Addendum No. 3
Four Rivers Sanitation Authority
Collection Systems Operations Facility
Capital Project No. 2217

This Addendum No. 3, dated February 14, 2023, for the above referenced project, supersedes all contrary and conflicting information in the specifications and contract documents, which are hereby supplemented or revised as follows:

New Collection
Systems Operation
Facility

Sheet Title
FIRE PROTECTION
OVERALL FLOOR PLAN

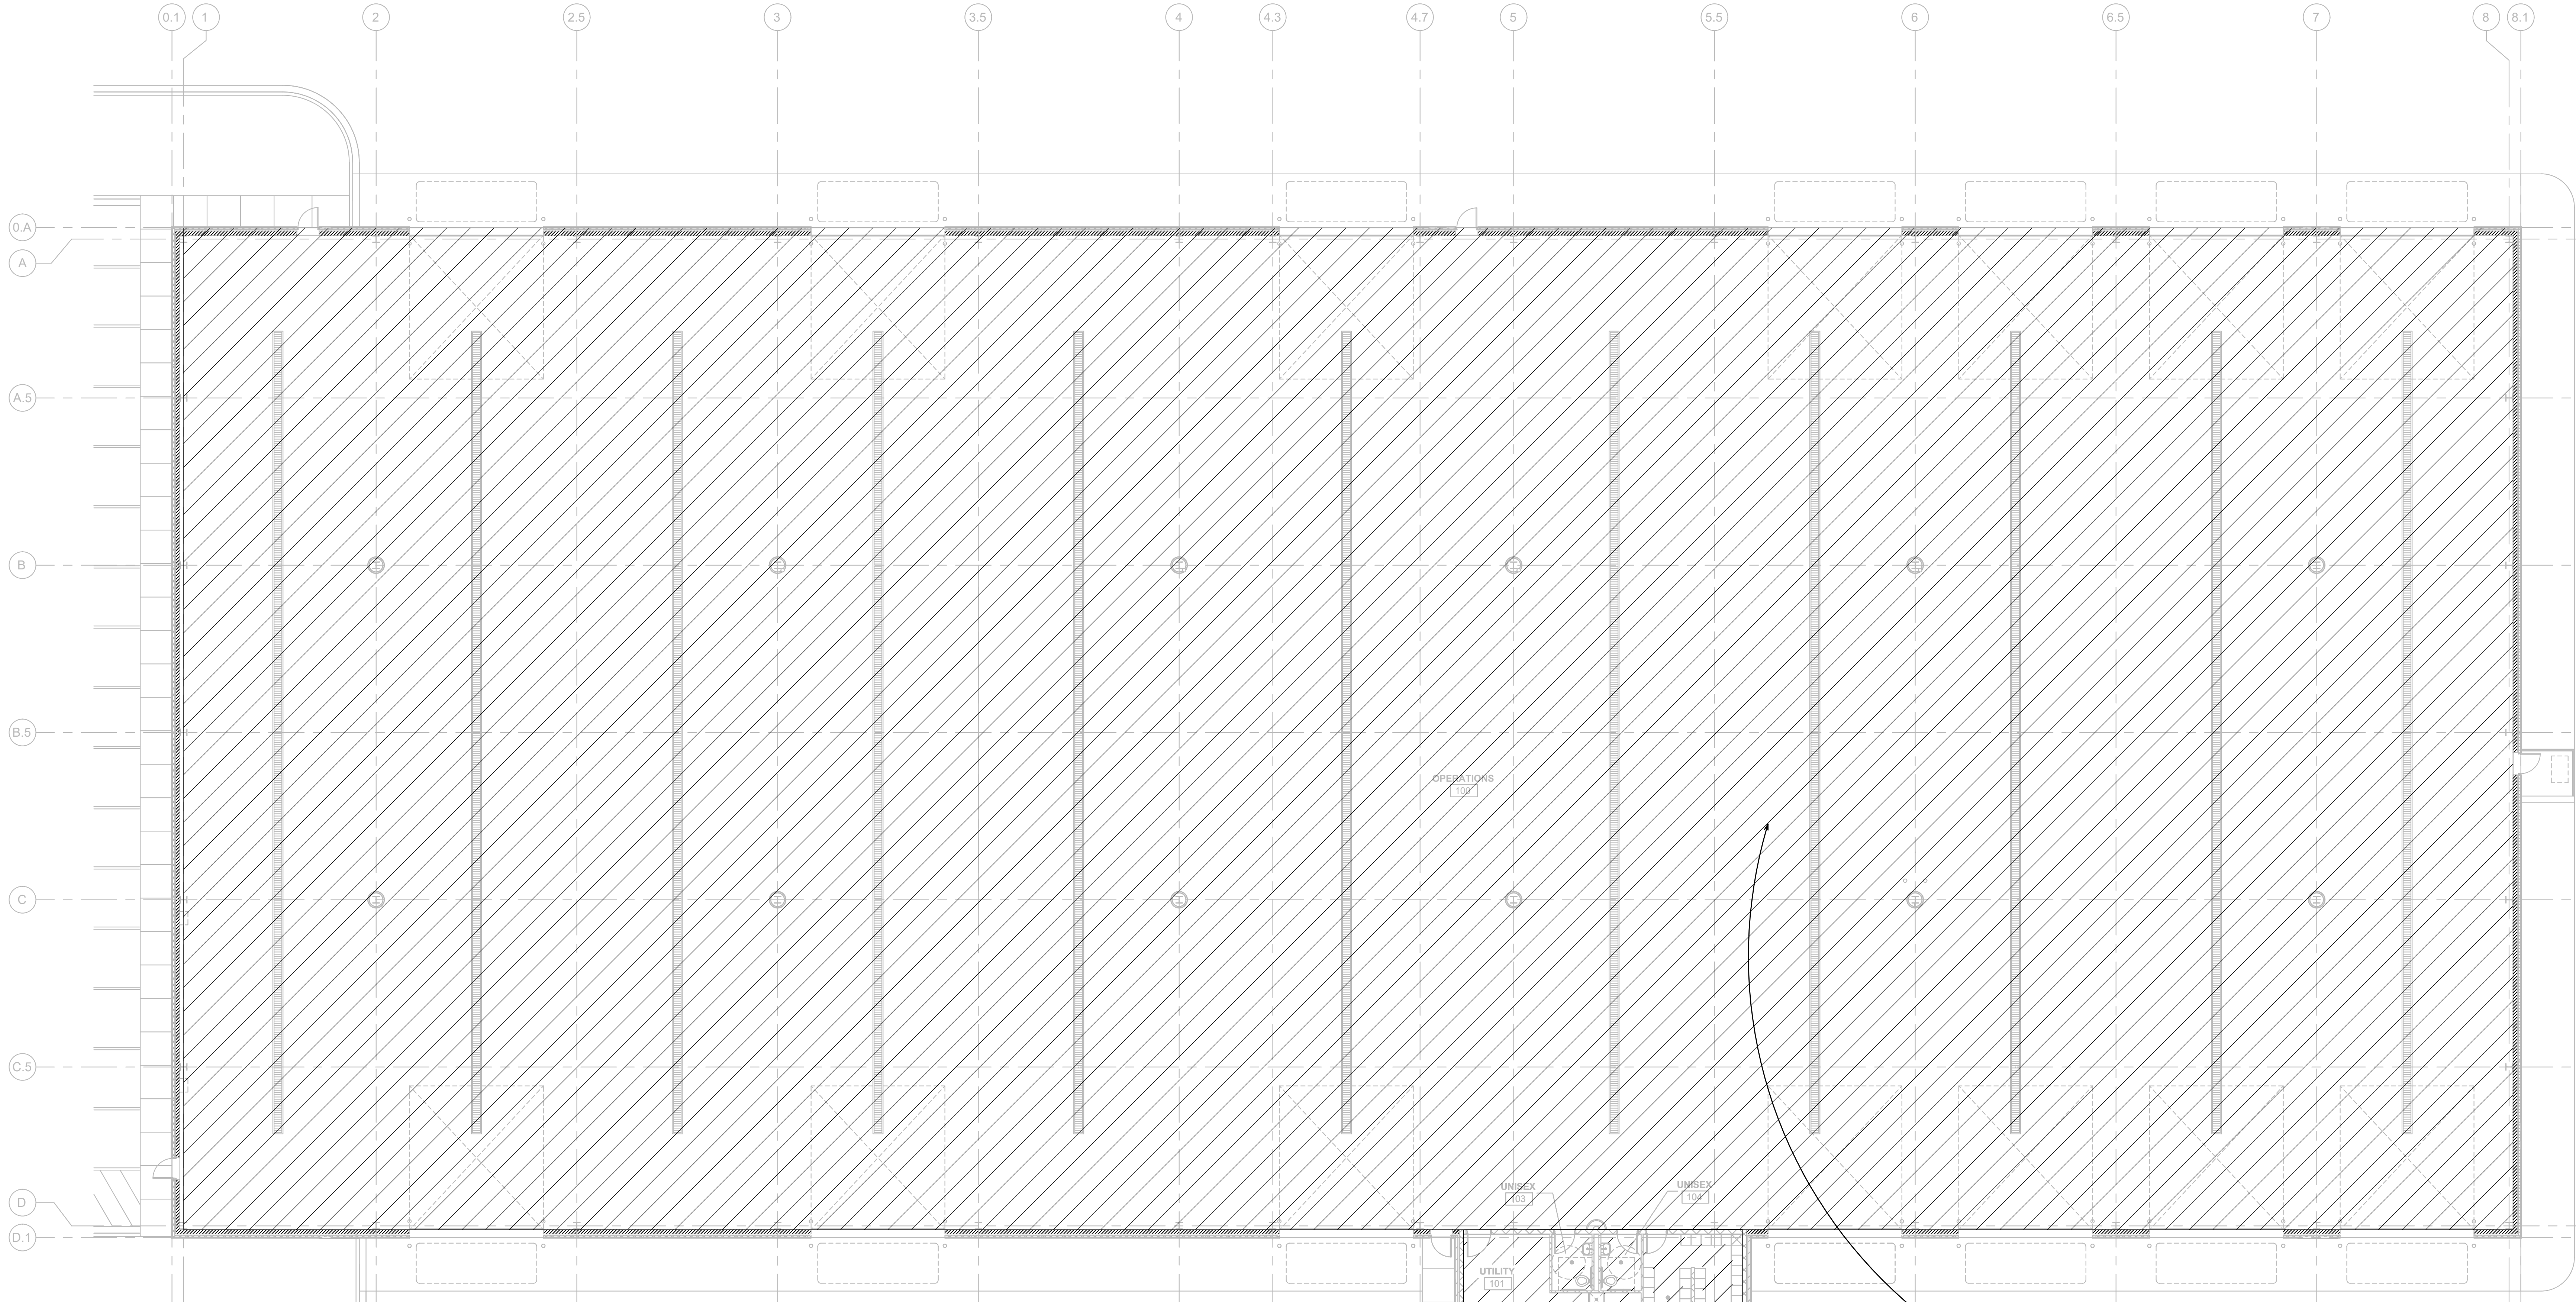
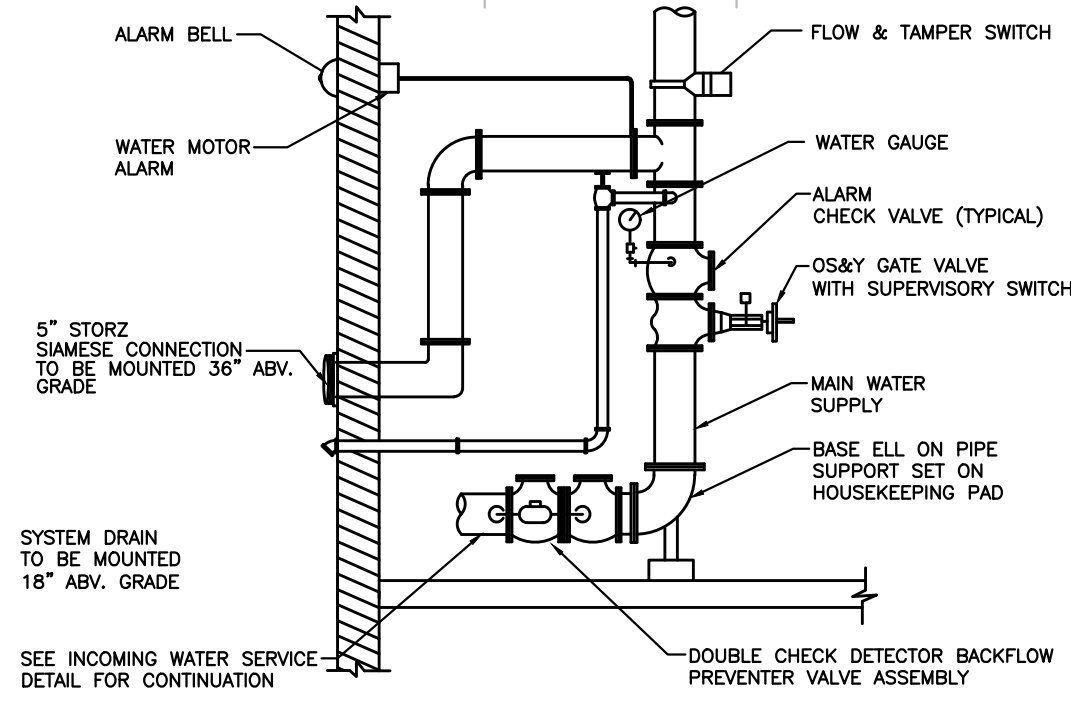
32. The fire riser indicates a remote fire department connection location and to refer to civil. Please clarify location.

Response: *Reference revised Plan Sheet FP101 for clarification.*
